**Landscape and Visual (L&V) Monitoring Report for
Harbour Area Treatment Scheme Stage 2A
(Operational Phase) (July 2022)**

Report No.: OT_2022009

Landscape and Visual Impact Assessment Checklist for Site Audit – North Point PTW

Figure 1	Figure 2

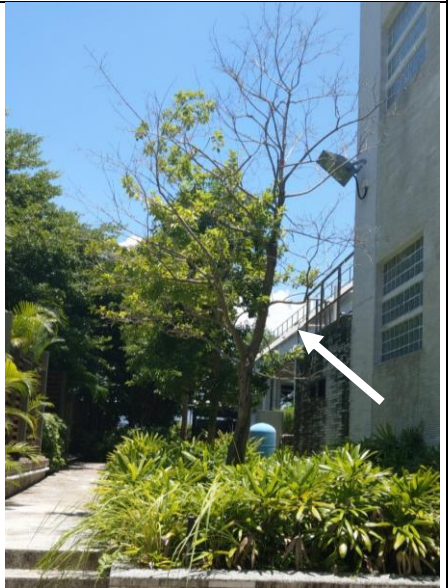
- Improvement of plant conditions of previous marked tree (Figure 2) was observed.

Figure 1	Figure 2

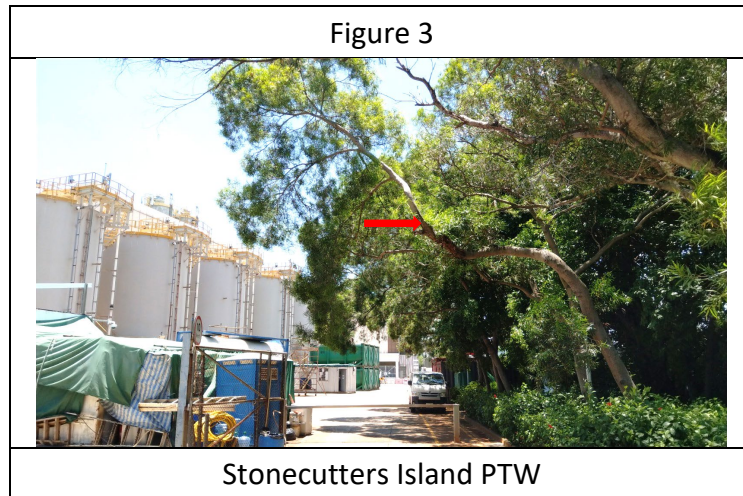
- Trees T110 & T109 have been removed.

1. Some existing trees adjacent to T110 & T109 are still found severely tilted and span over driveway (shown in Figure 3). It is recommended that maintenance party to review if pruning is required.
